OICA-TF 09/30/2022: Configurations of the alternative lateral impact test §7.2.4.3

§ 7.2.4.3

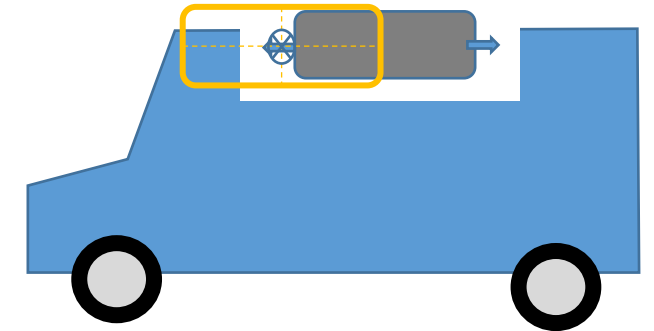
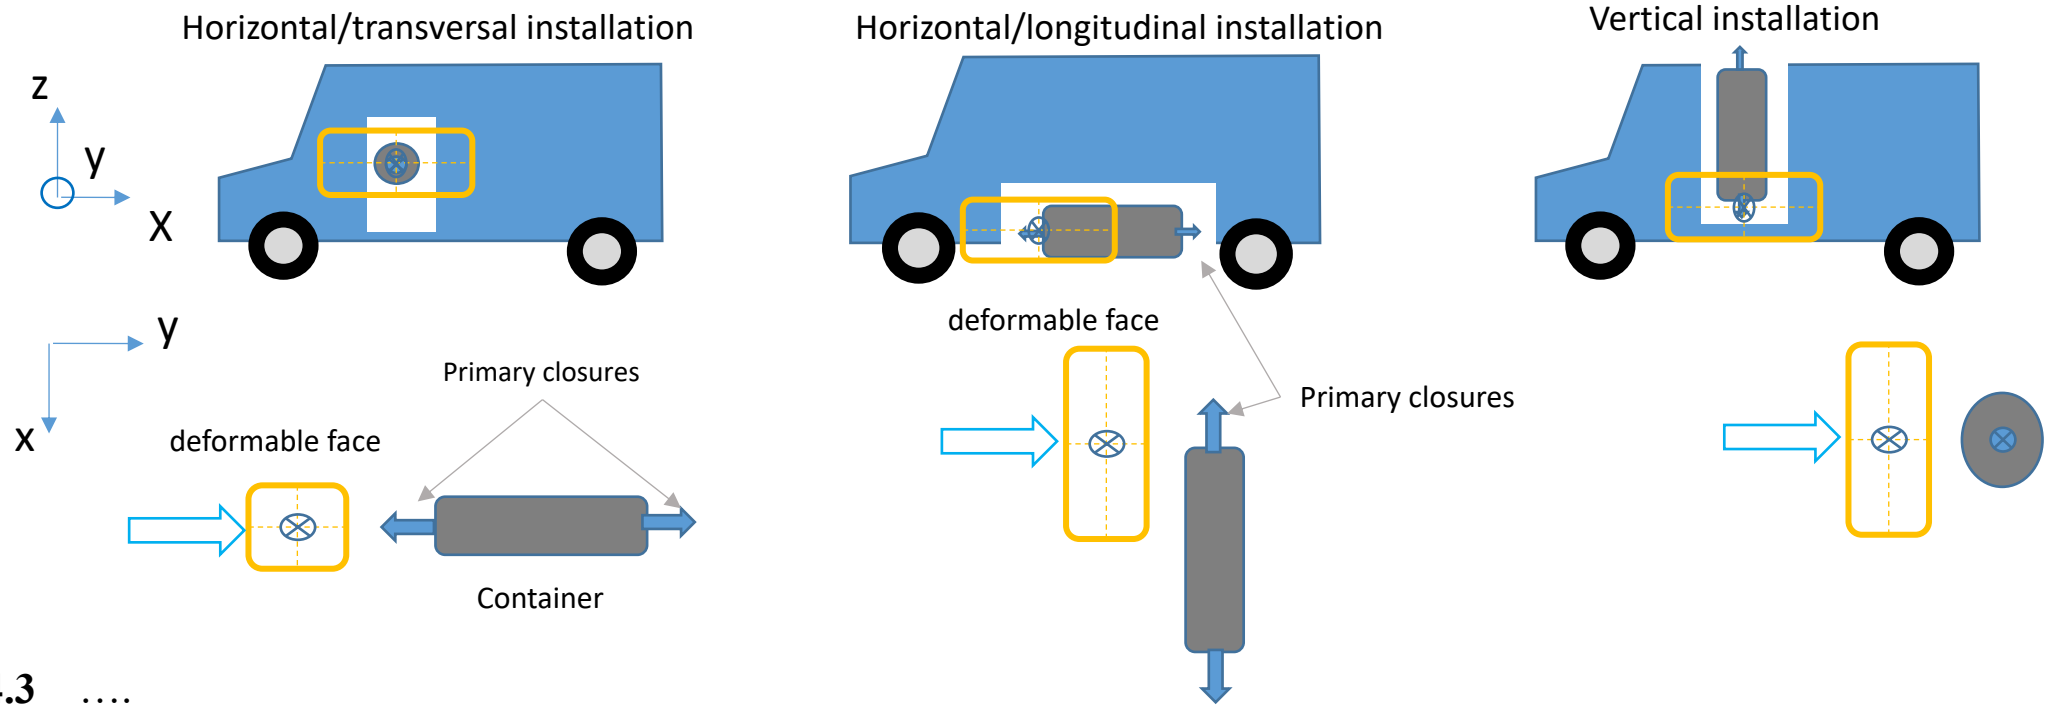
Amend § 7.2.4.3.2. ~~Movable deformable barrier~~-Impactor (striker)

The ~~The movable deformable barrier (MDB)~~ the impactor includes both a deformable face and rigid support structure. The characteristics of the deformable face shall comply with the requirements of UN Regulation No 95 Annex 5. The impactor face may either mounted on a pendulum, a drop tower or be secured to a carriage (moving barrier).

Amend § 7.2.4.3.3. Lateral impact on compressed hydrogen storage system

The impactor energy shall be 90 KJ ~~MDB speed at the moment of impact shall be 50 ± 1 km/h~~. However, if the test was performed at a higher impact ~~energy speed~~ and the compressed hydrogen storage system met the requirements, the test shall be considered satisfactory. The impact direction shall be in an angle of 90° to the longitudinal axis of the test set-up as defined in paragraph 7.2.4.3.1. and the CHSS ~~container~~ shall be adjusted in a way that the middle of the front plate of the barrier matches the **target point** middle of the **primary closure location** ~~container~~ in the horizontal and vertical. ~~In case more than one primary closure location, the worst case impact area shall be selected for the test in agreement with the technical service. The target point of the container is on the central height of the container and [300 mm apart from the far end of the primary closure devices]~~
